Bowdens Proposal: Hydrogeology

IPC 15 Feb 2023

Lue Action Group

Craig Flavel - Field Development Planning

Figure 3: SW-NE Cross Section Source: GoogleEarth 2022

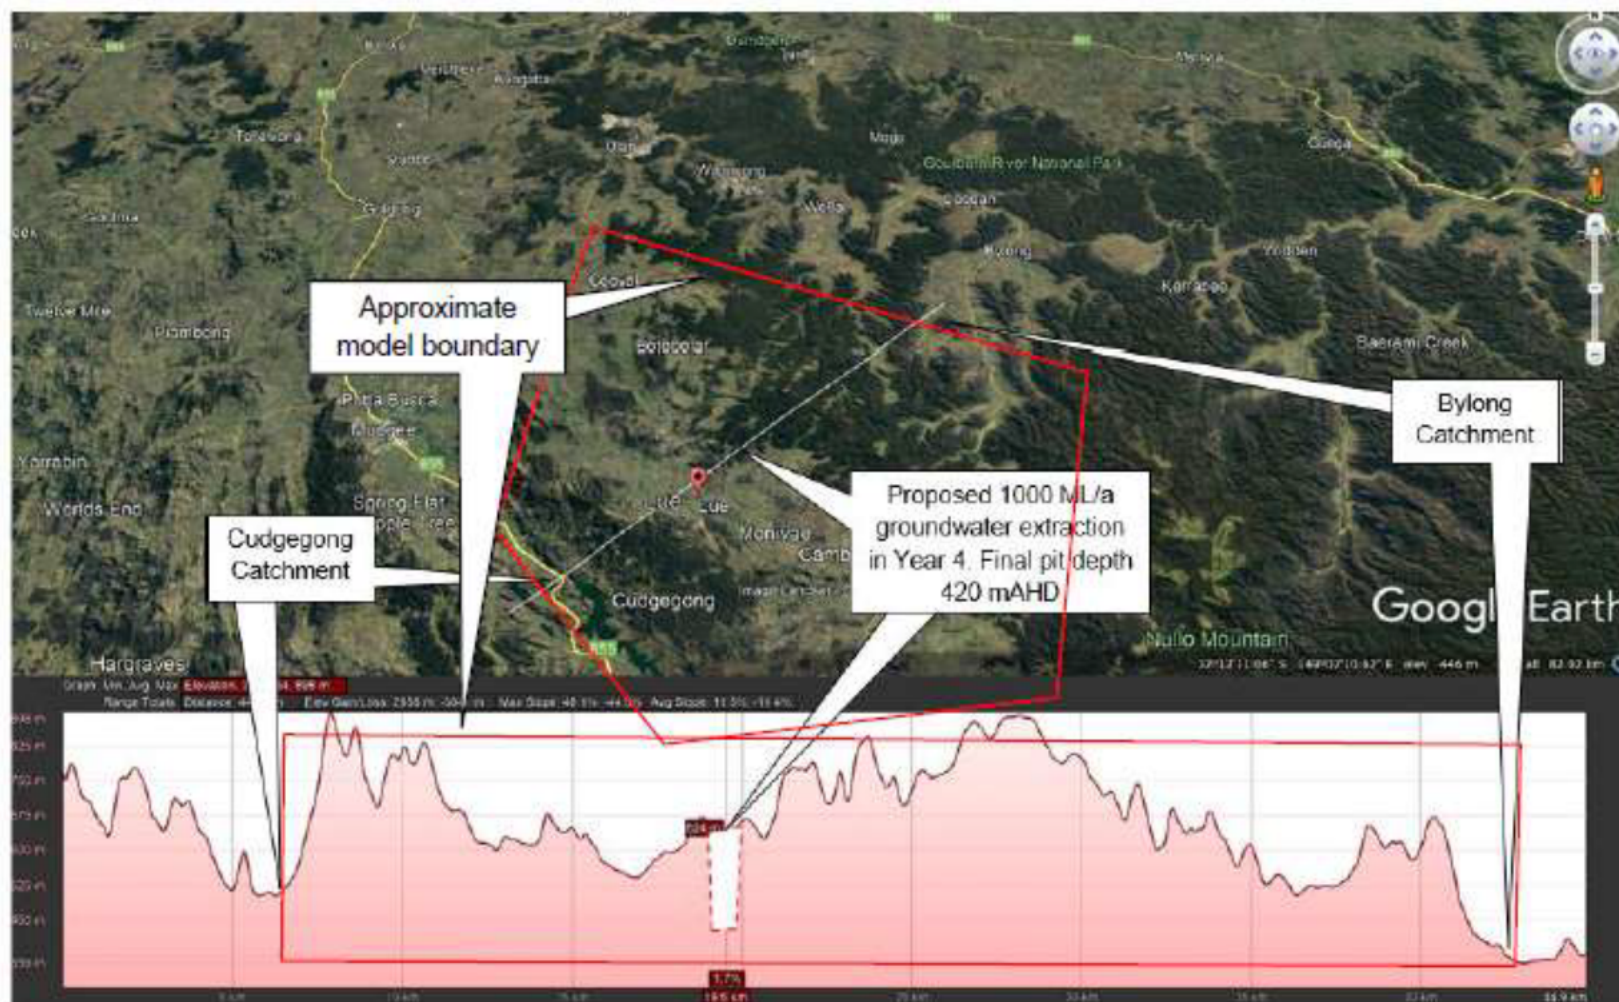
‘no water quality impacts beyond 40 m from the Mine Site boundary and no changes to the beneficial uses of aquifers are predicted’

40 m in Context: potential to alter regional hydrology

NW-SE Section during proposed dewatering – showing potential GDEs

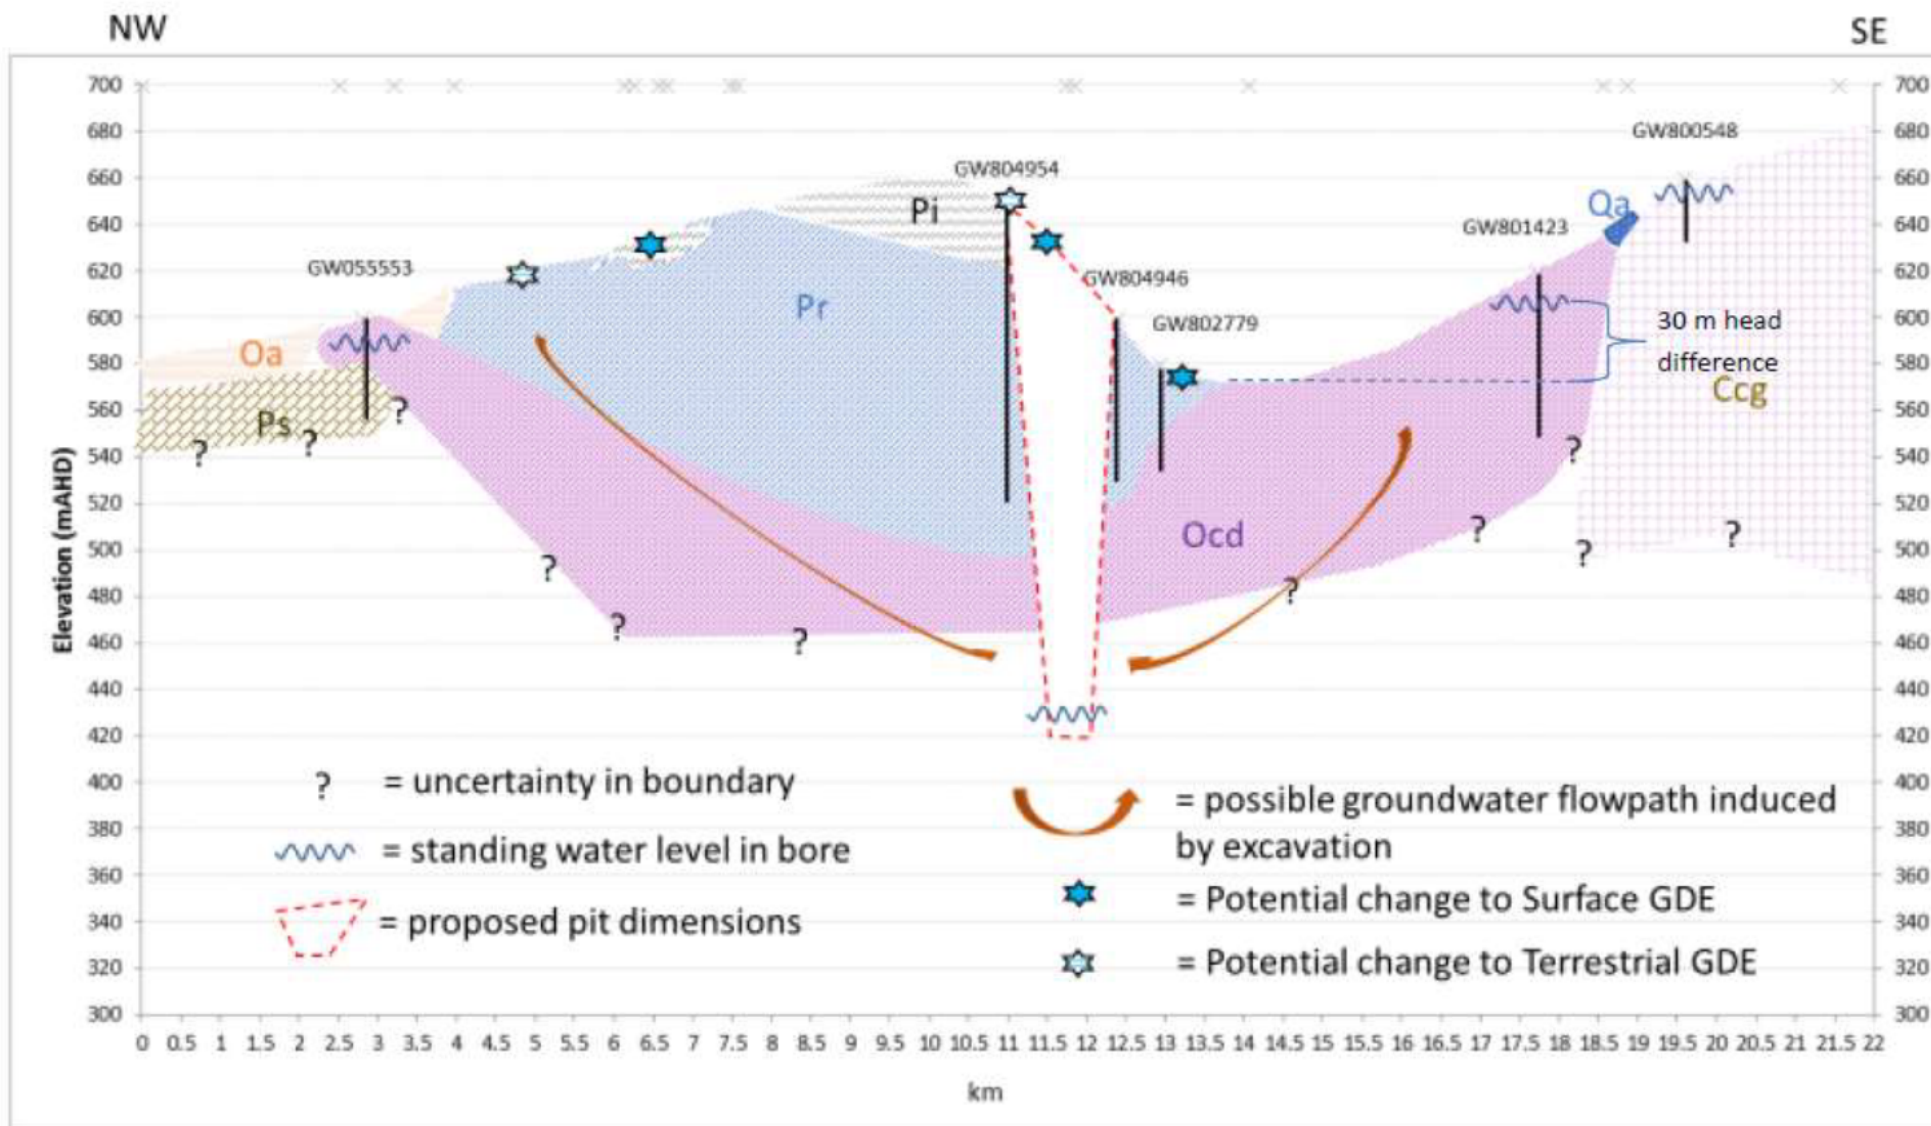
1. Creeks and surrounding alluvium aquifers can support significant aquatic species
2. No evidence of investigations targeting endemic aquatic species in local springs, nor the nature of their groundwater dependence
3. Under-utilised hydrogeological information:
 - The conceptual model appears to be based on a literature review rather than site data
 - No evidence of significant hydraulic barriers laterally or vertically around the site
 - R.W Corkery & Co. (2021) state that the objective of the numerical groundwater simulation model was **not** to consider contamination of local springs nor dependent ecosystem health

Figure 4: Site Geology, adapted from (R.W. Corkery & Co., March 2022c, pp. 2-10)

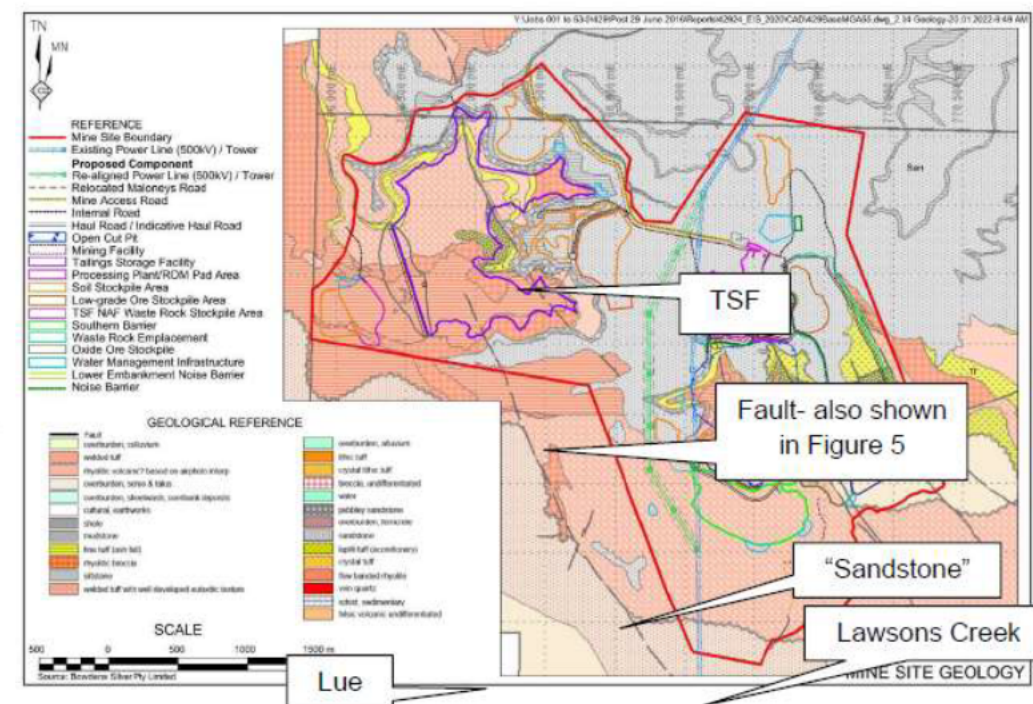
1. R.W. Corkery & Co. A4 (Feb 2022): enhanced permeability within fractured rock aquifers near major geological structures

1. AIP 14: there is potential for causing and enhancing hydraulic connections that has not been clearly presented.
2. AIP Table 4: potential unquantified water quality impacts on nearby licensed groundwater users

Figure 35 Predicted Drawdown at End of Mining (Year 15.5)

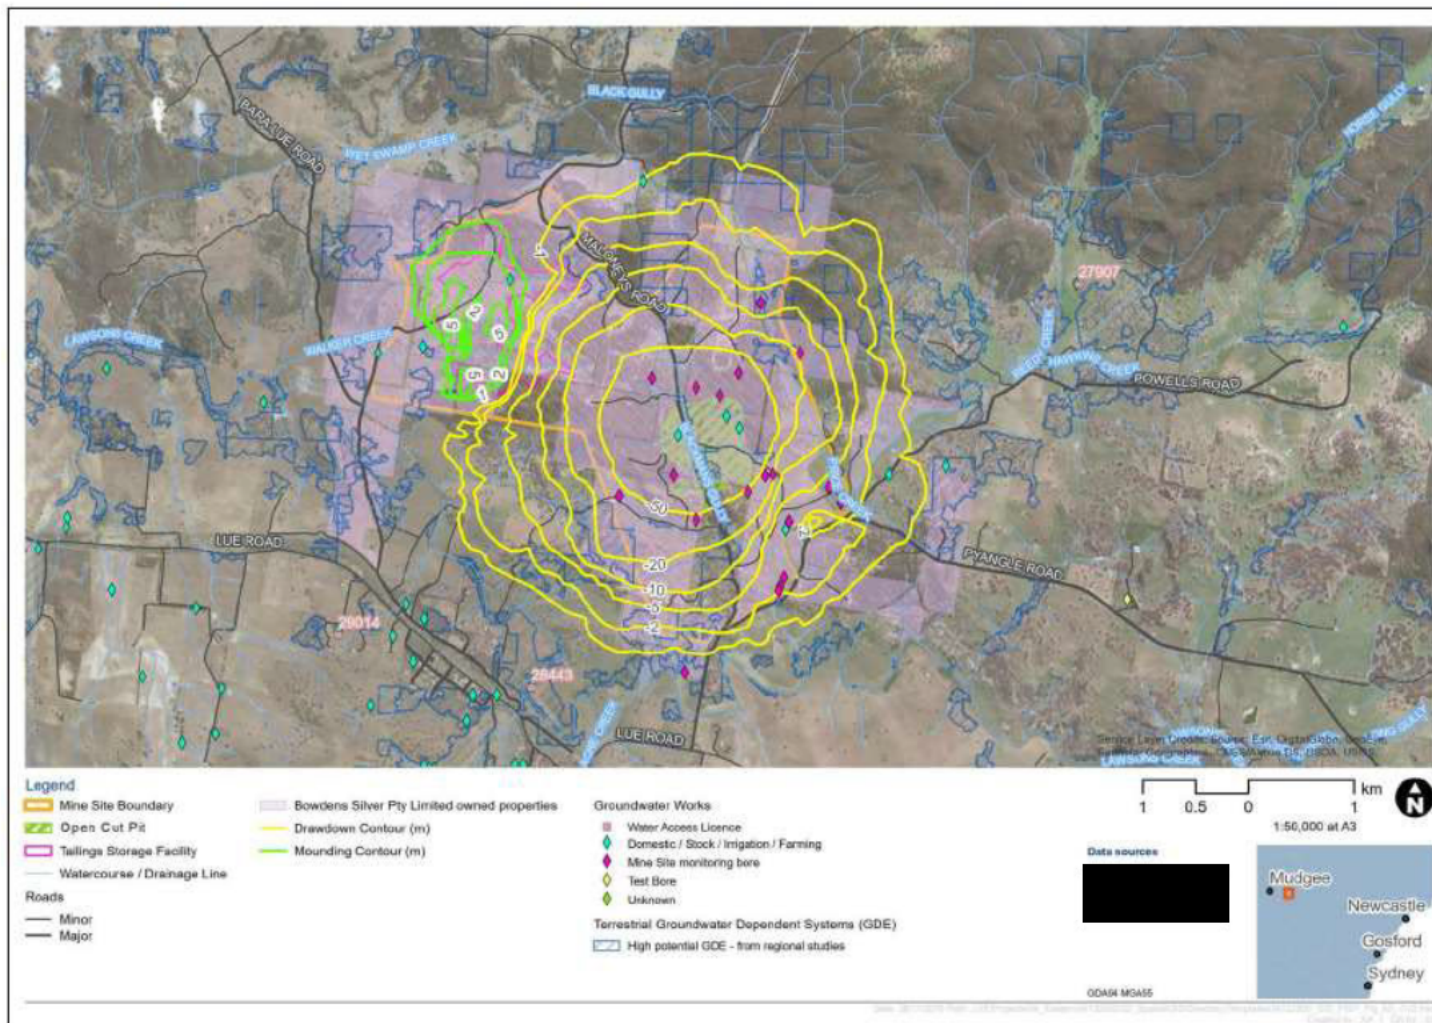
1. The post mining groundwater flows are **unlikely** to be towards the pit
(R.W.Corkery & Co. Dec 2022 & HydroGeoLogic Dec 2022)
2. Significant and unexplained alterations to model Layer 1 and 2 were made around the TSF in 2022 (HydroGeoLogic 2022)

Groundwater flowthrough to Hawkins Creek

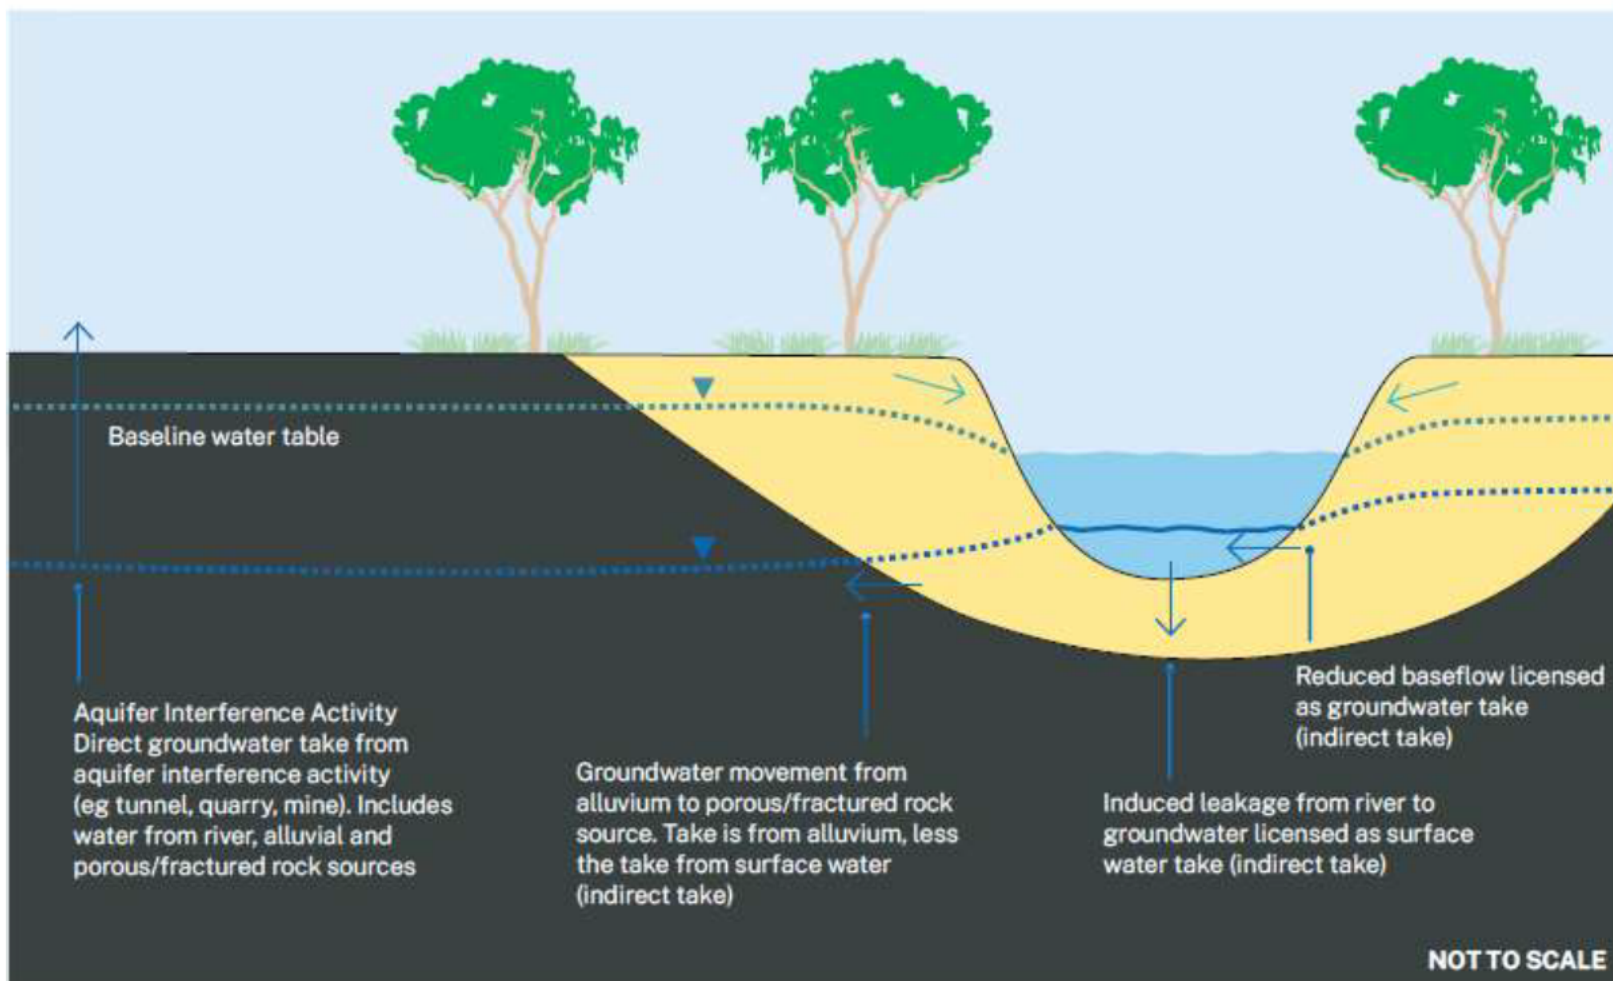
1. Potential seepage is predicted from the TSF and WRE (and Leachate Dam)
(Jacobs 2020, 5-125)
2. 200 litres/day of seepage under the (ANCOLD 2012) TSF embankment
(ATC Williams, 2020, p.24)
 1. The nature, mass or attenuation of contaminants leaching from the TSF or WRE to the south and west of the site after 100 years has not been provided.
 2. Seepage collection is uncertain in fractured rock aquifers.
 3. Long term management and response has not been specified
3. Amendment 2-45: An *unconditional* commitment to applying a bituminous liner to the entire area *and* monitoring integrity *and* specific response would help limit seepage
